WINDERMERE

PRELIMINARY PLAN

EL PASO COUNTY, COLORADO

COUNTY FILE NO.: SP 1413/EA 18200

PP01

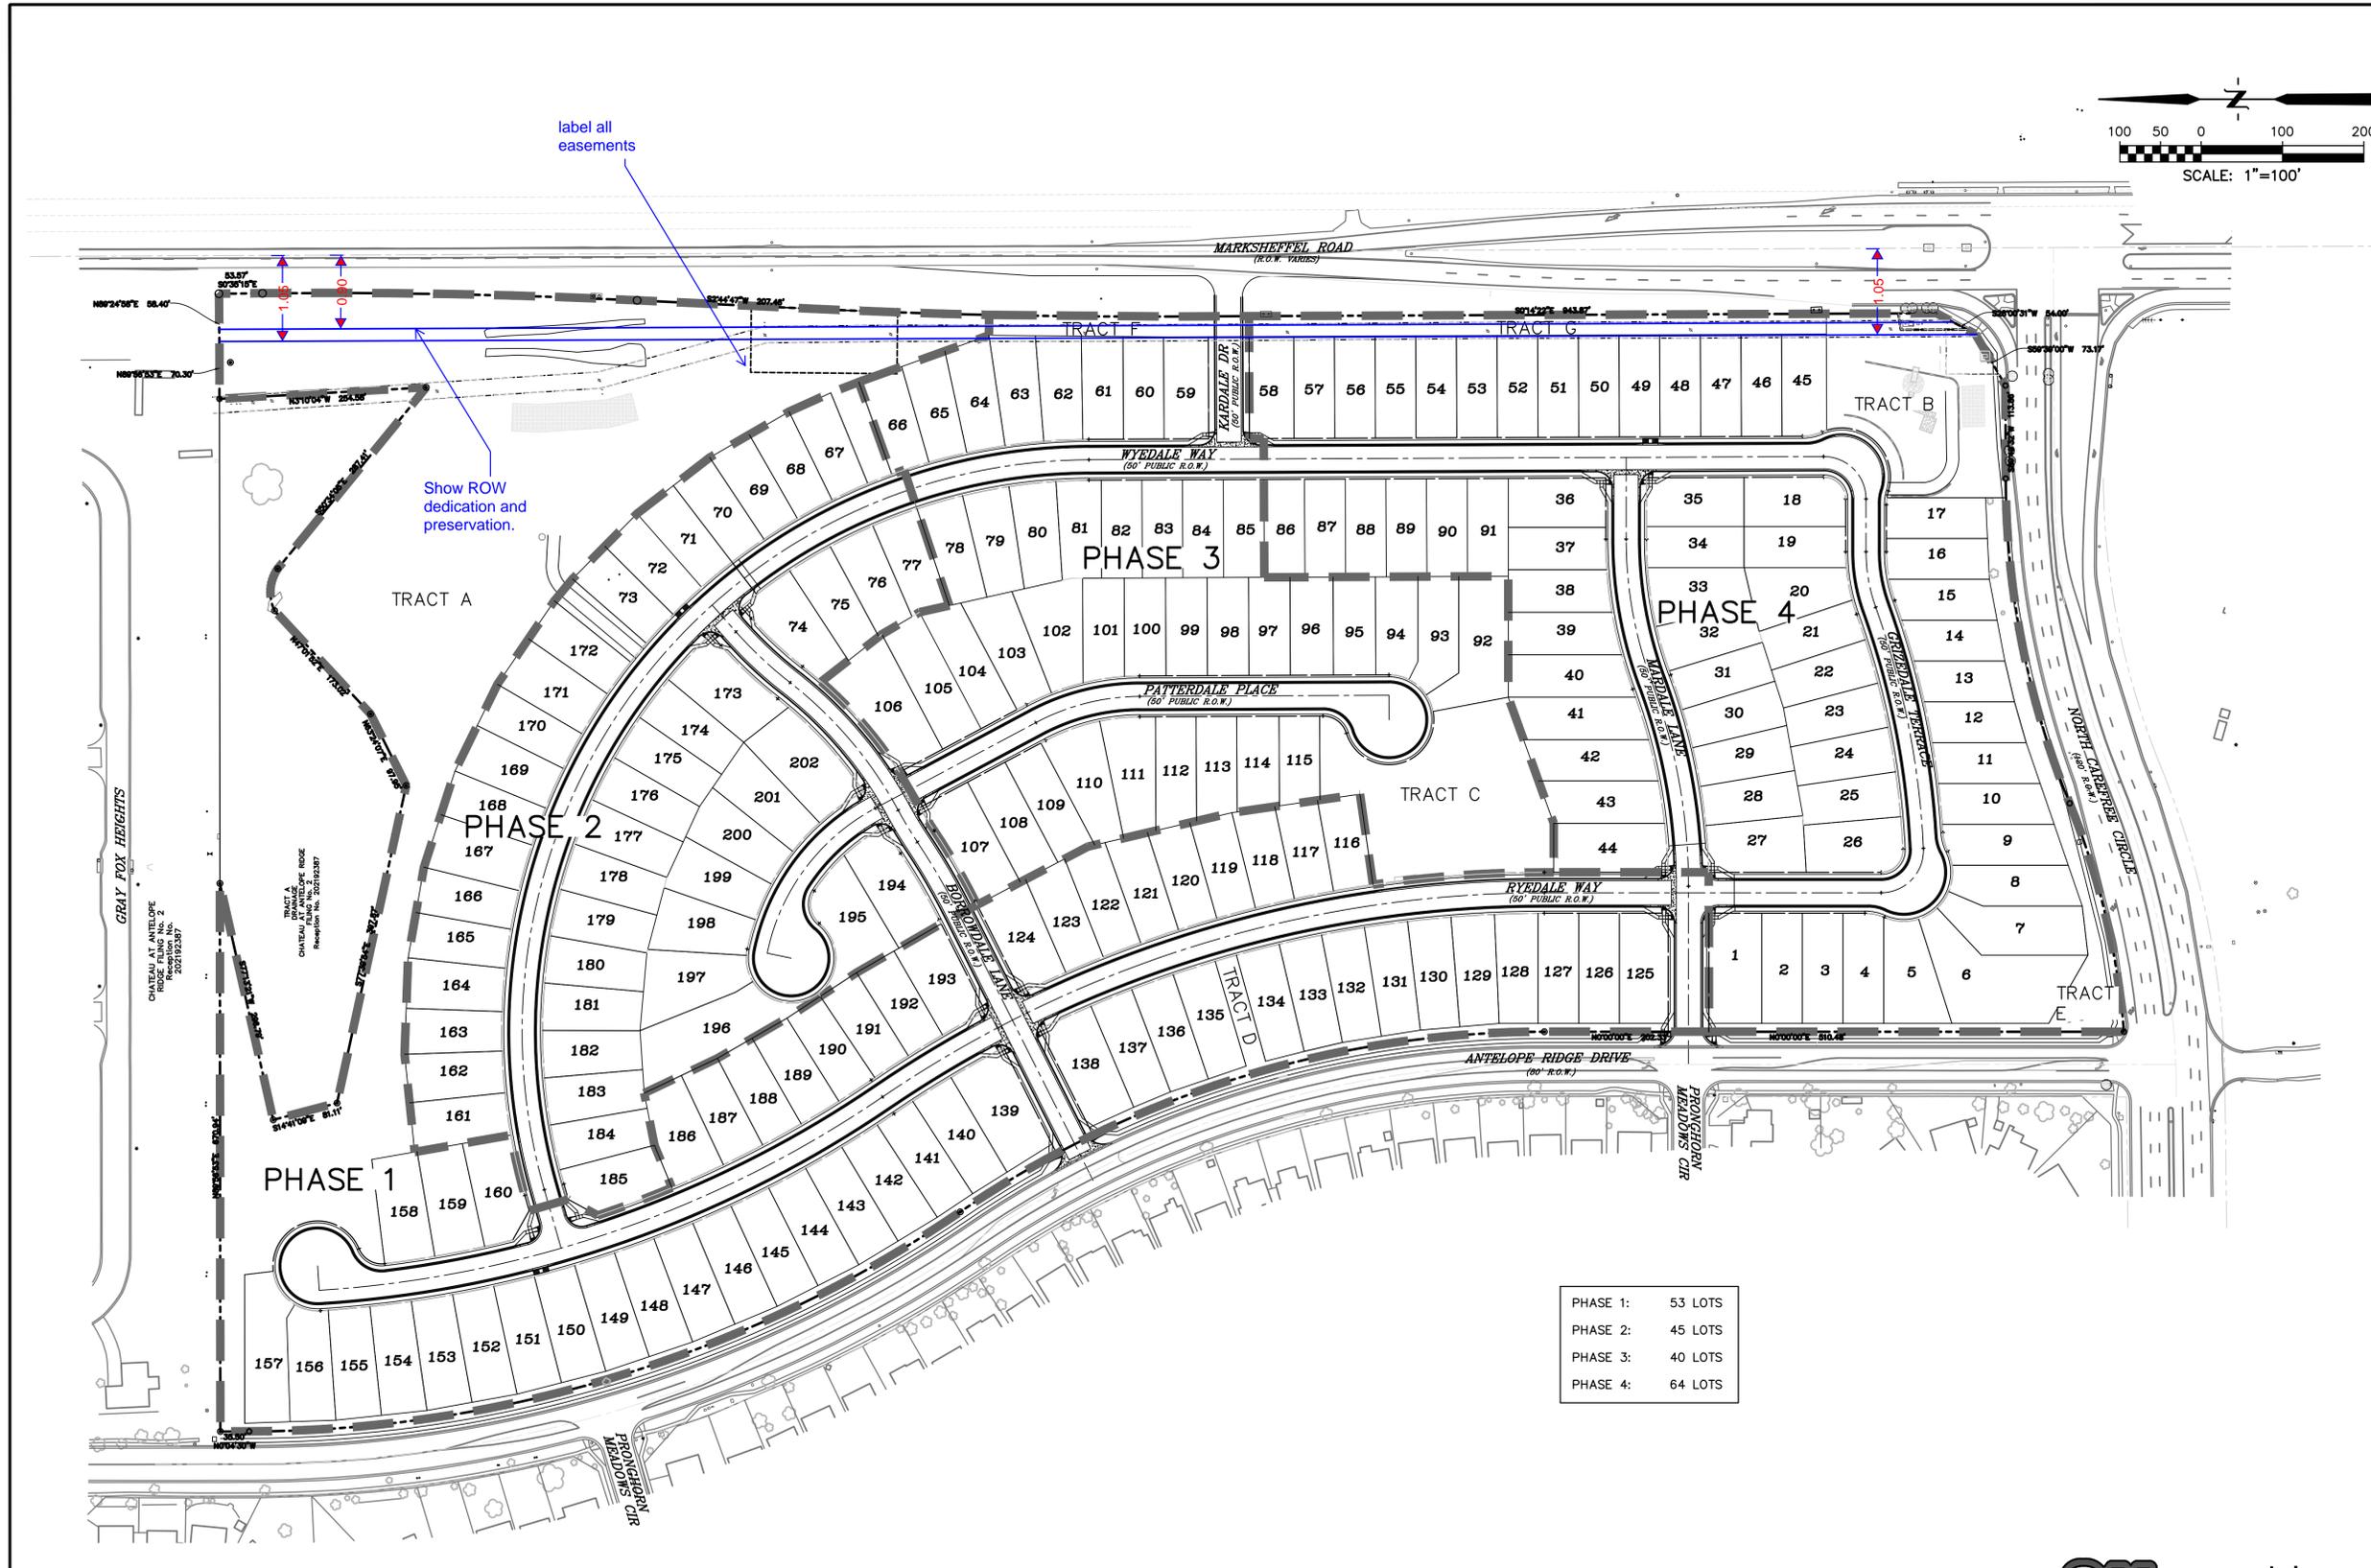
See comment letter.

Provide all Preliminary Plan checklist items.

all check list items should be on sheets 2-5 (Checklist uploaded) A full review will occur when resubmitted.

Provide the detail of the sound wall (study identified 8-feet, Code allows for 7- feet) a 7' wall & a combination of plantings may be necessary. Have noise provider determine if a combination is necessary in lieu of 8-foot wall. Show wall on prelim plan map.

Customize Notes and add- Identify lots impacted. Geo report needs to be submitted

Sub-regional pond and the small pond?????

how will this be enforced; The County cant enforce that... provide clear direction. Landscaping is not allowed in the ROW w/o a landscape license agreement (what is the justification to have one-unlikely here)?

- CONTOUR INTERVAL SHOWN ON PLAN 2'.
- PUBLIC UTILITY/DRAINAGE EASEMENTS SHALL BE PROVIDED ON ALL LOTS AS FOLLOWS:
 FRONT: TEN (10) FEET
 SIDE: FIVE (5) FEET
 REAR: TWENTY-FIVE (25) FEET
 SUBDIVISION PERIMETER: 220'
 No- This cant be.
 25 drainage easement is not correct on rear lots? The setback is as much.
 delete- you are paying fees per LOLfor correct LOL

Are Tracts F and G for ROW?

PP02

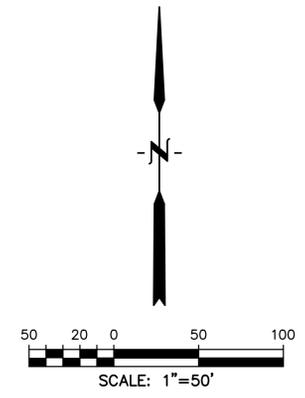
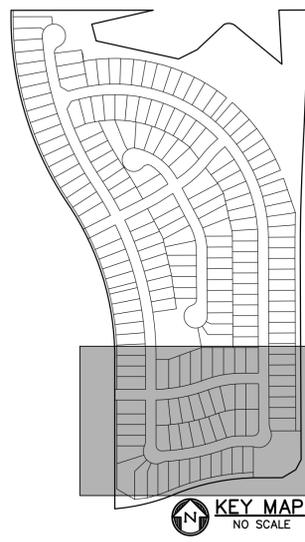
label all easements

Show ROW dedication and preservation.

PP05

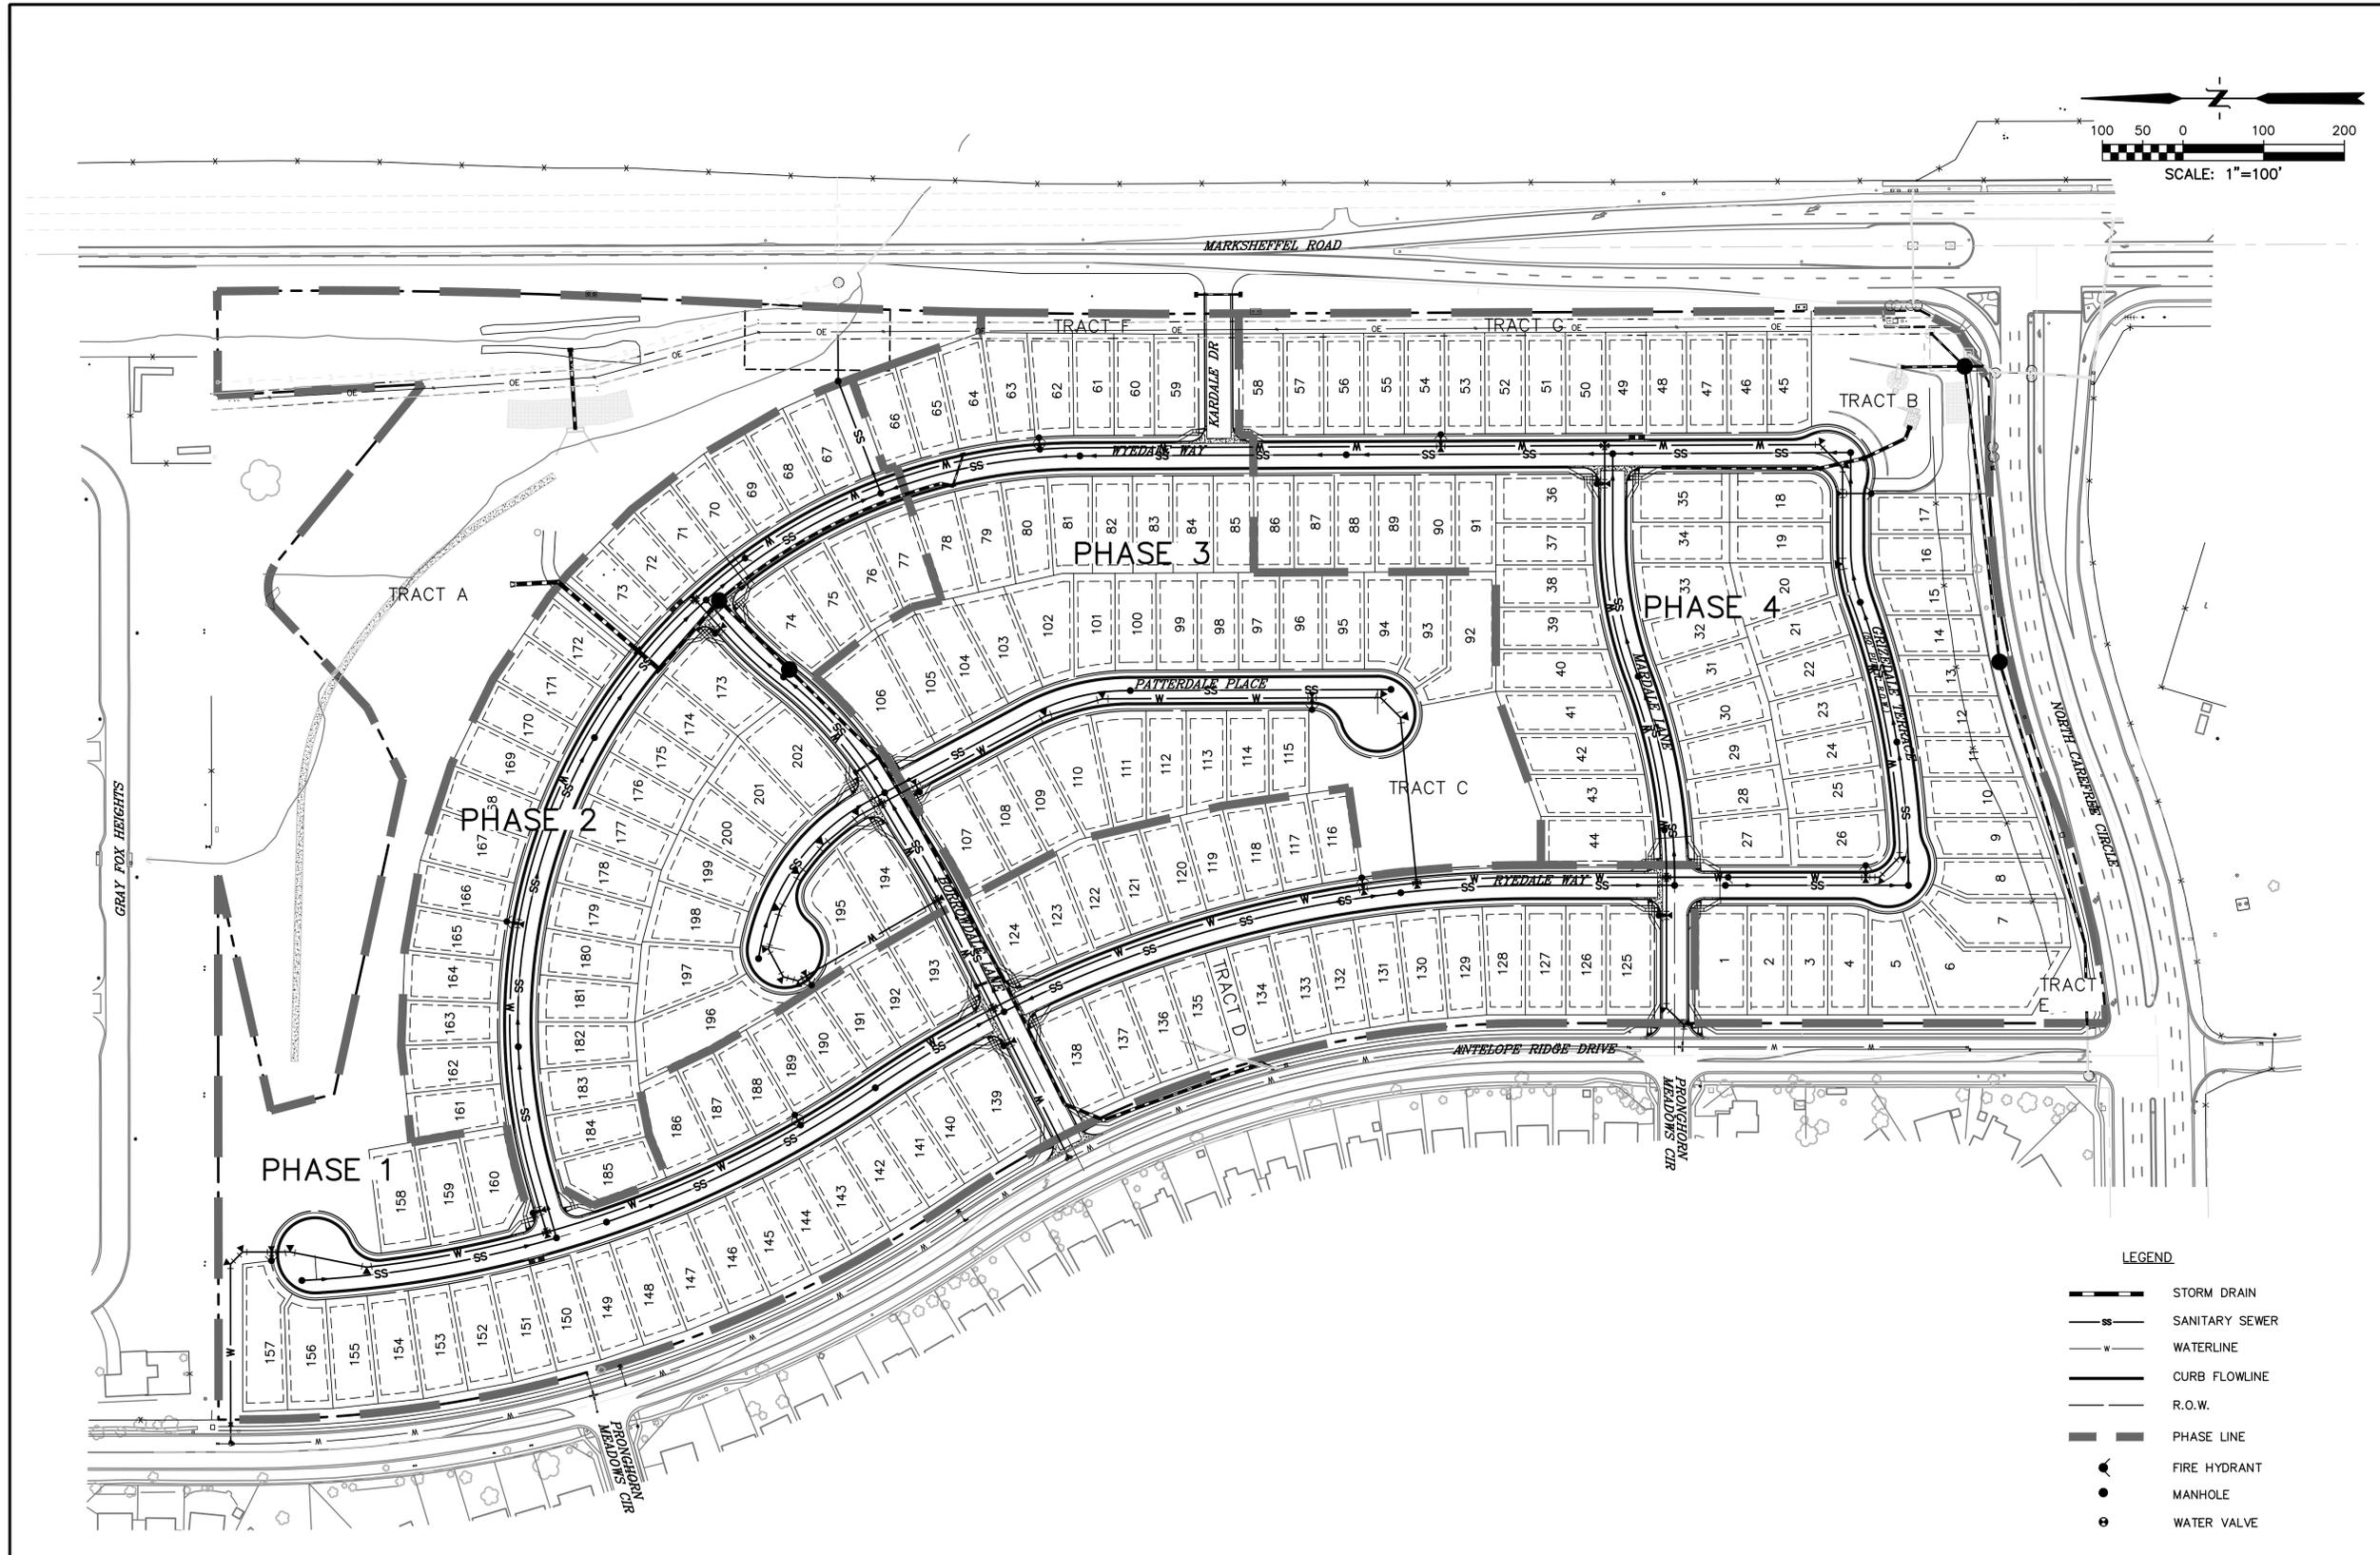
Provide additional ROW to accommodate sidewalk.

Show noise wall

Show sight distance lines.
